Application for Variation of an Environmental Permit

C2. Application No. of the Current Environmental Permit : AEP-393/2010

**Agreement No. CE 6/2015 (EP)
West New Territories (WENT)
Landfill Extension – Design and
Construction**

Supporting Document for Variation
of Environmental Permit

Drawing no.		Rev.	
FIGURE 9.5		A	
Drawn	Date	Checked	Approved
GL	04/22	IL	FC
Scale	Status		
1:10000 @A3	PRELIMINARY

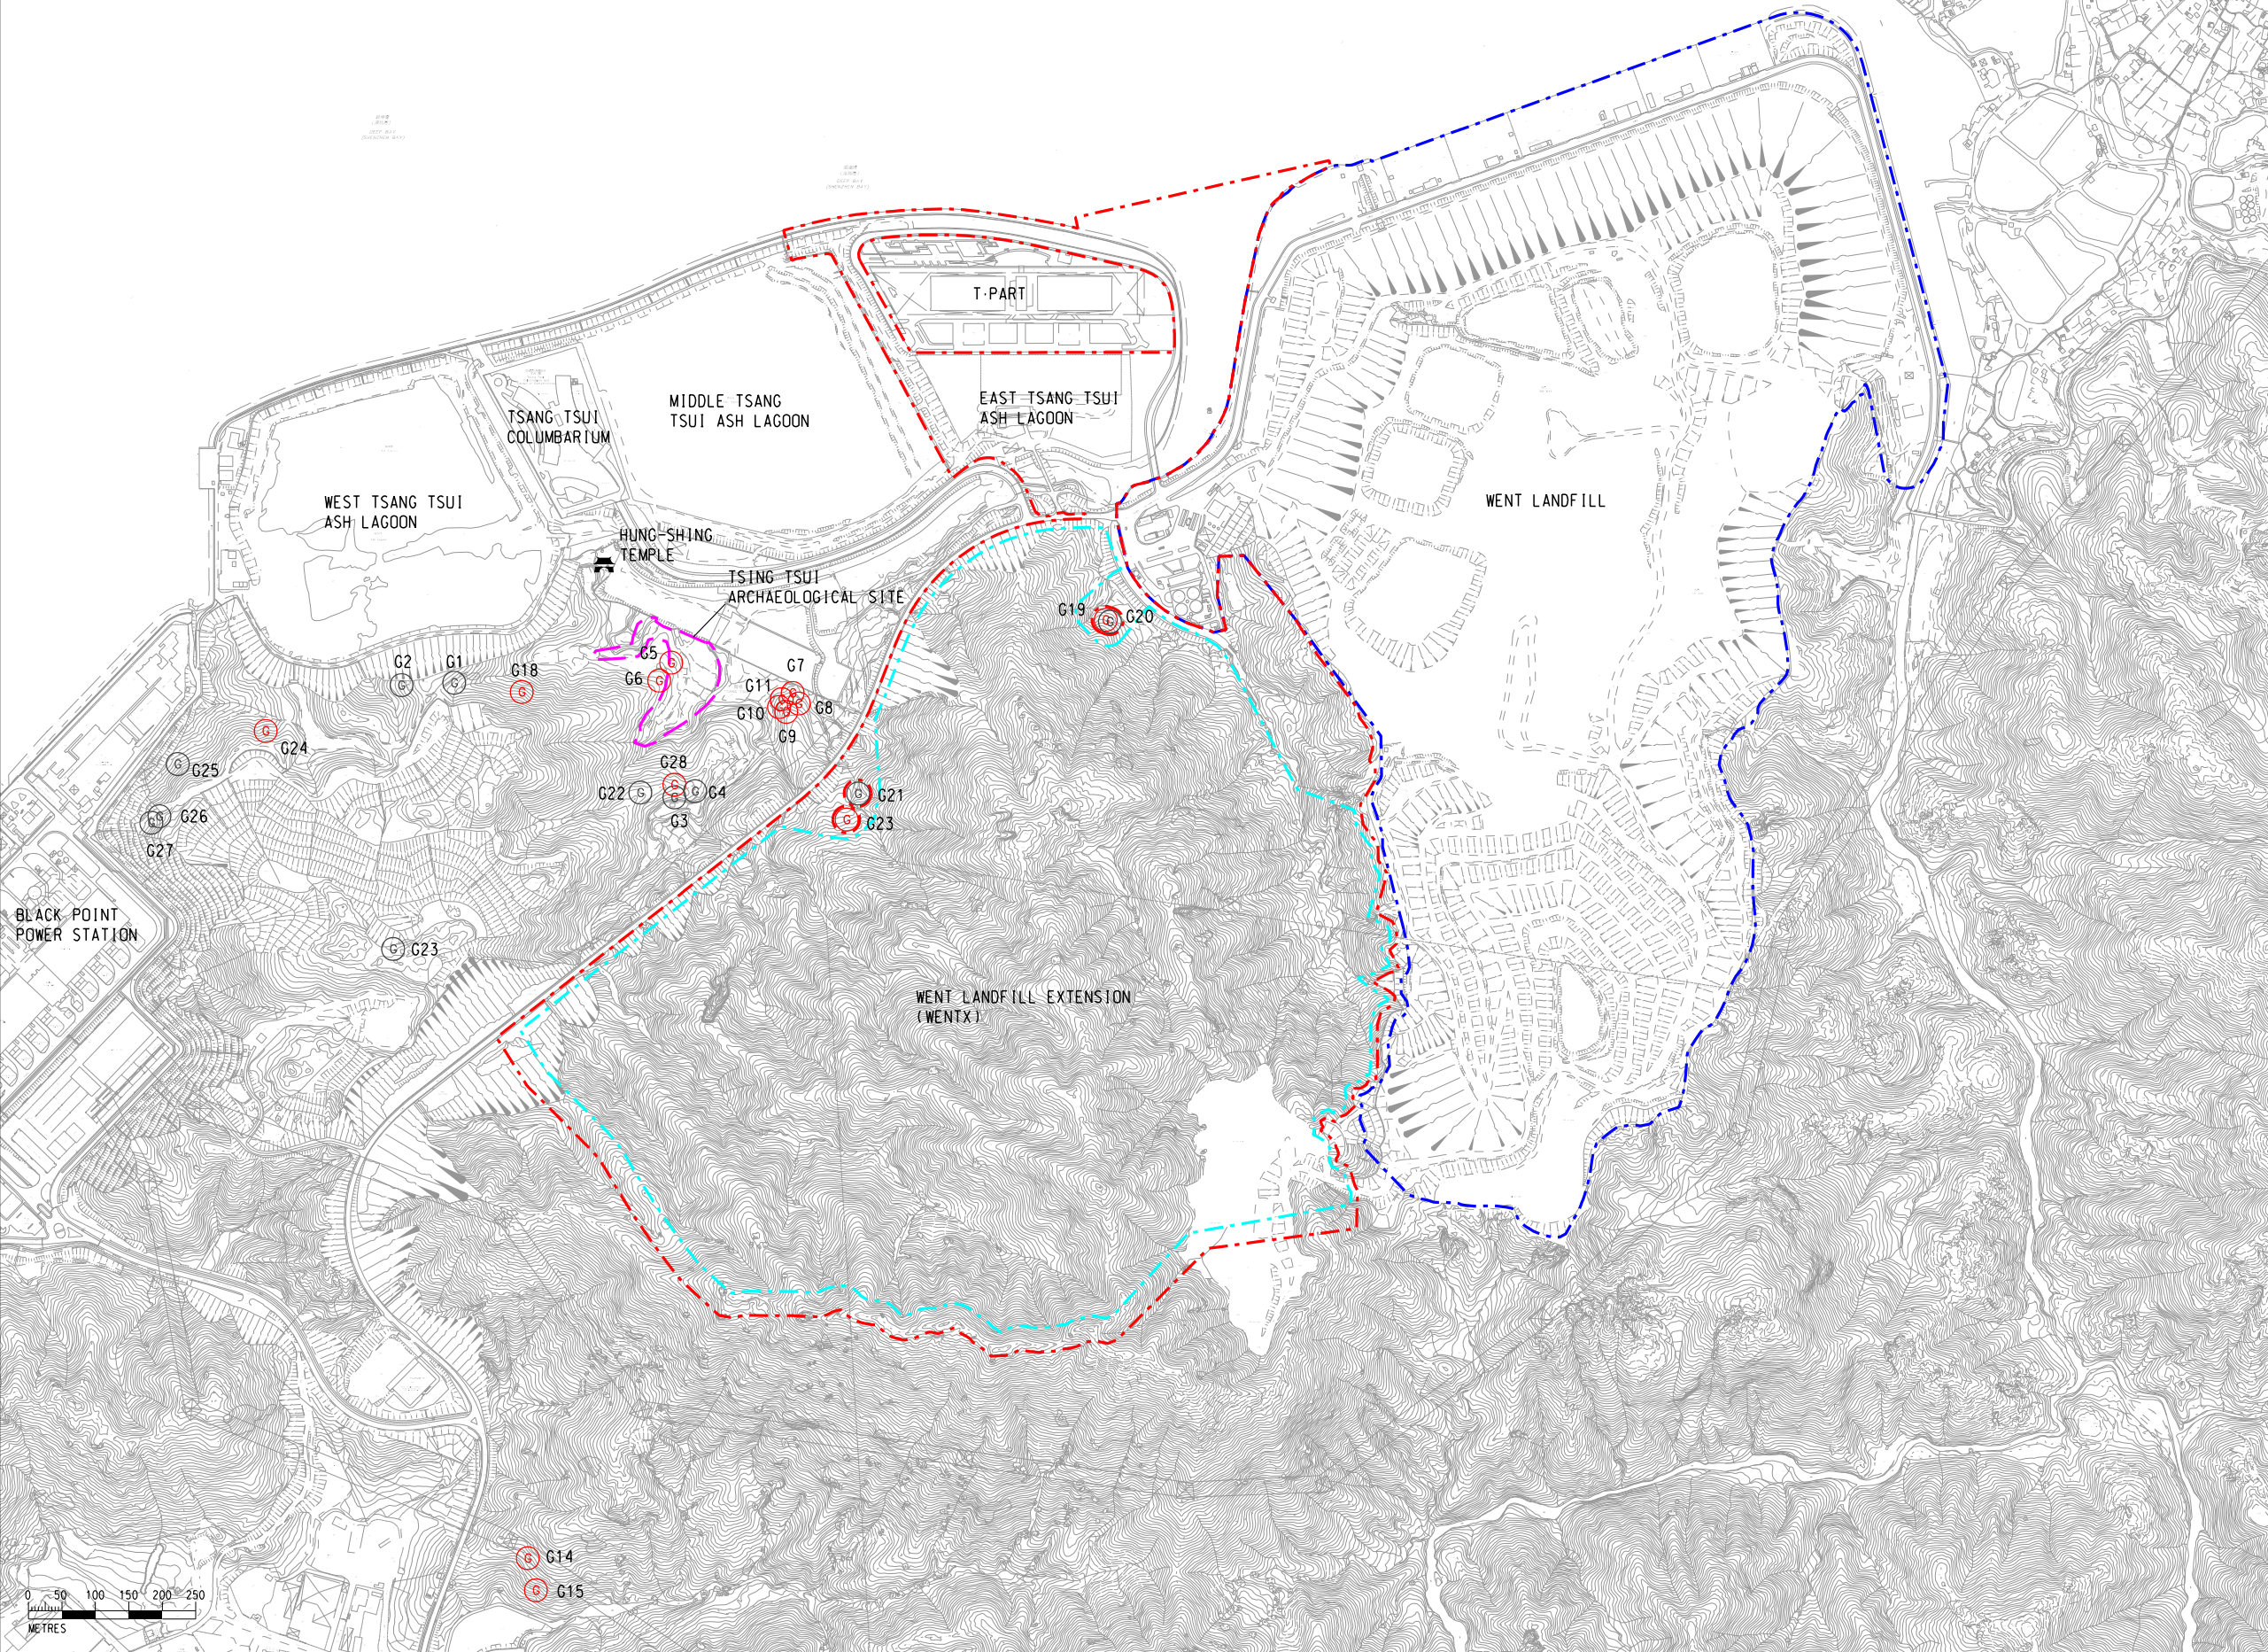
9.3.1 Under the Enhanced Scheme, the revised boundary will totally avoid encroachment onto the TTAS, graves and temple (**Figure 9.5**). No potential cultural heritage impact due to the Project is anticipated, and thus no mitigation measures are required for the Enhanced Scheme.
